City of Detroit
City Engineering Division, Department of Public Works
Survey Bureau

GLWA GPET 18-60

NOTICE OF PROPOSED CHANGE IN PROPERTY

Petition: x504

CITY OF DETROIT CITY ENGINEERING DIVISION	
SURVEY BUREAU	
JOB NO.	01-01
DRWG. NO.	X 504

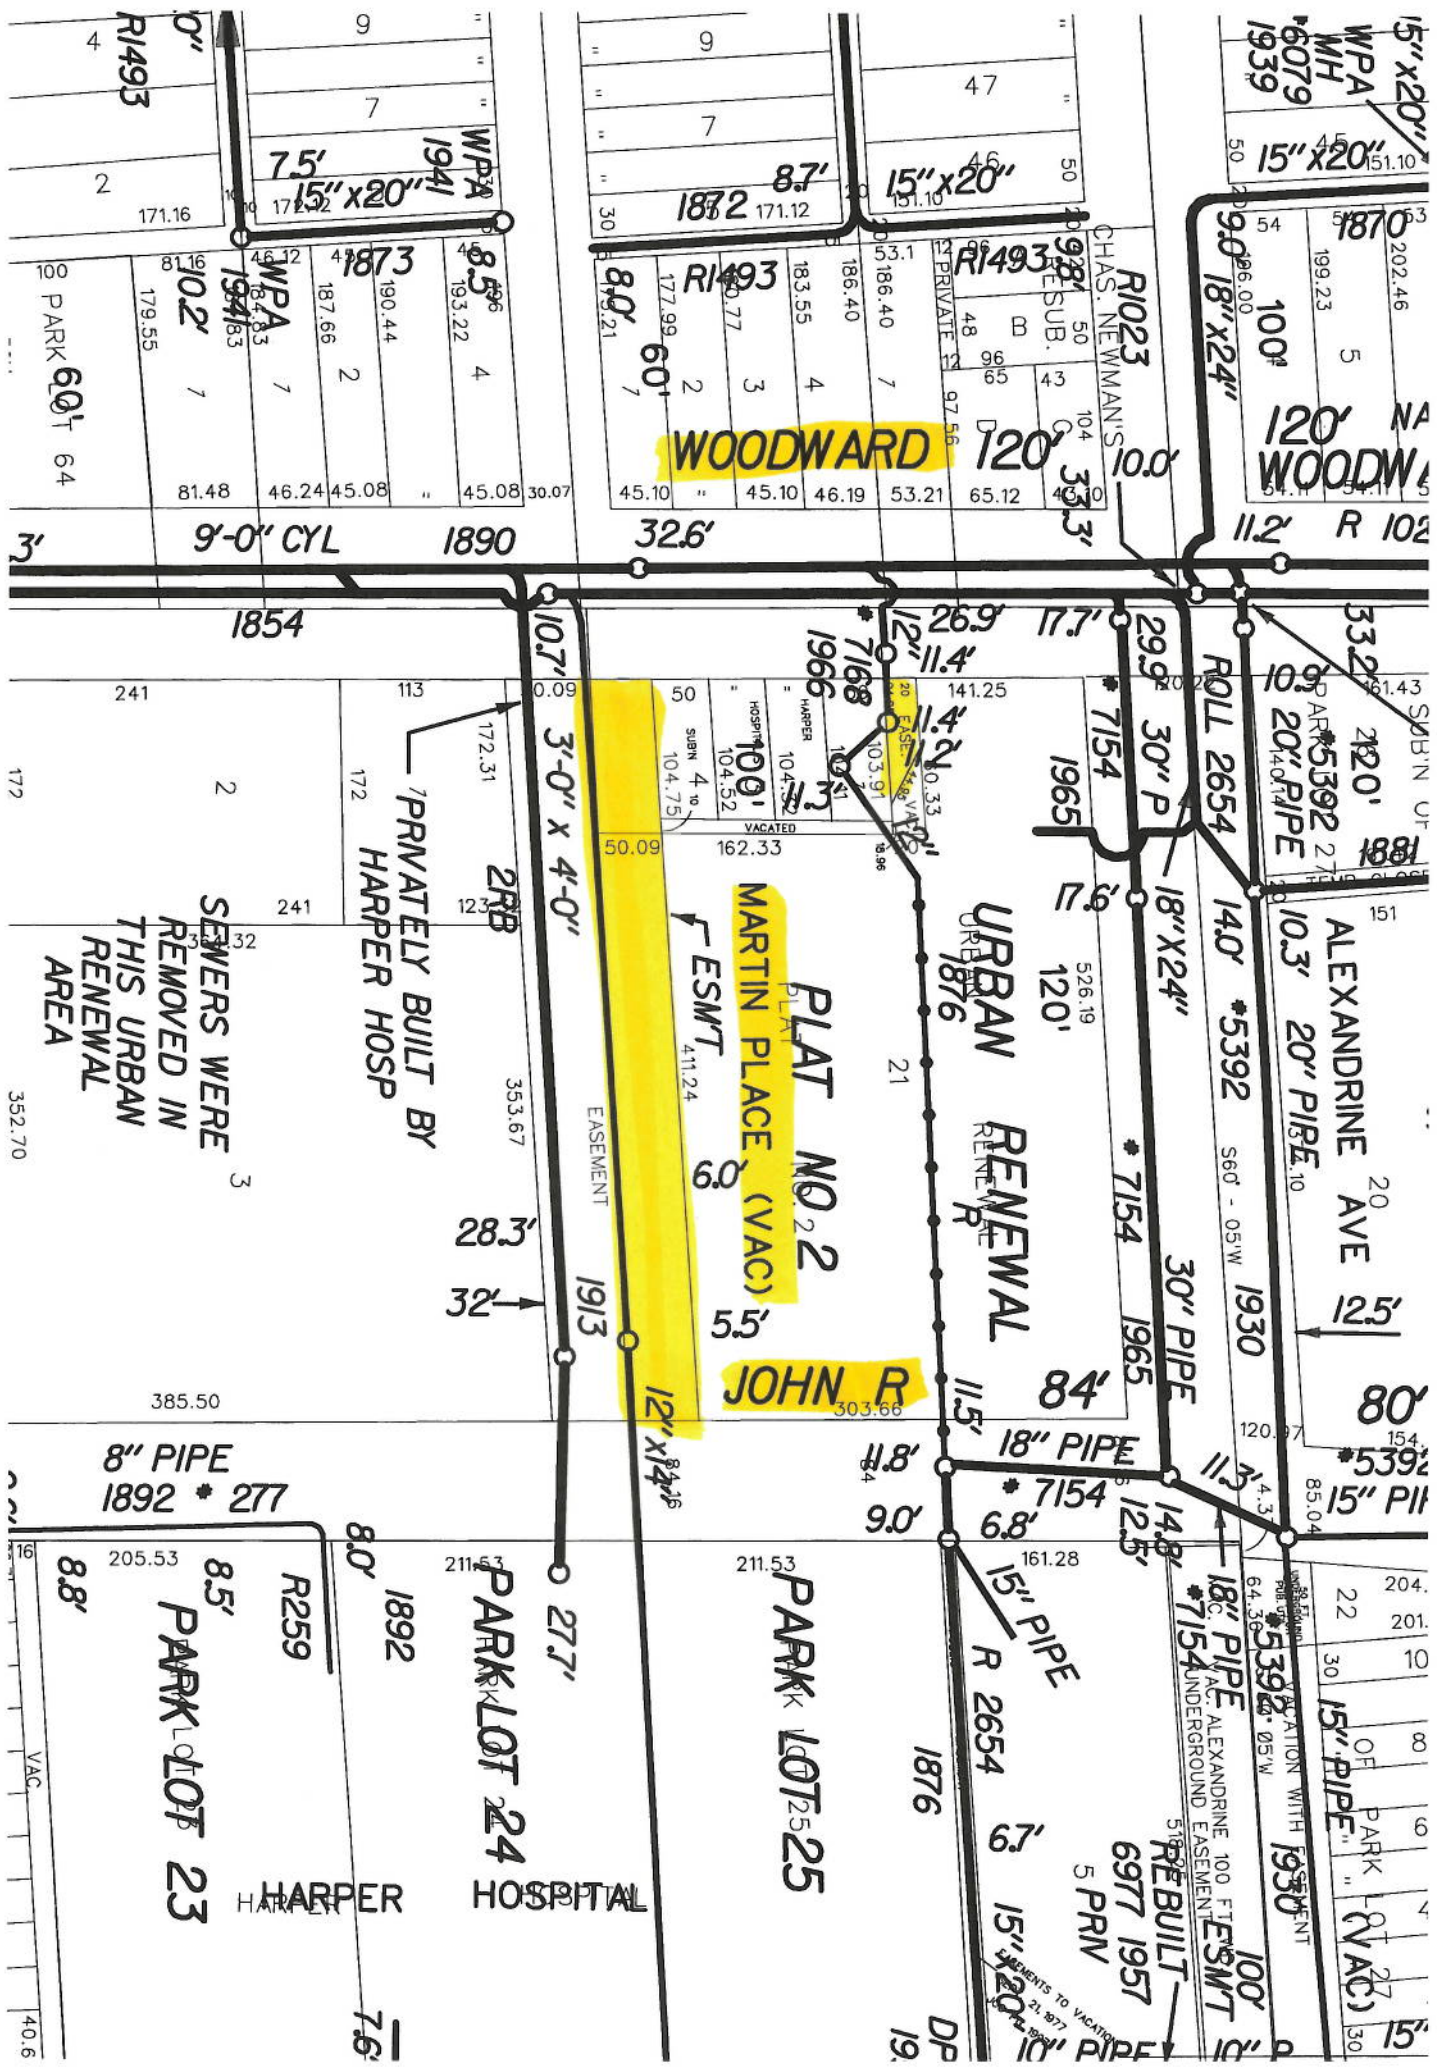
The proposed change in property (referred to on the other side of this sheet) would affect our services as follows:

URAP - GLWA
(Utility or City Department)
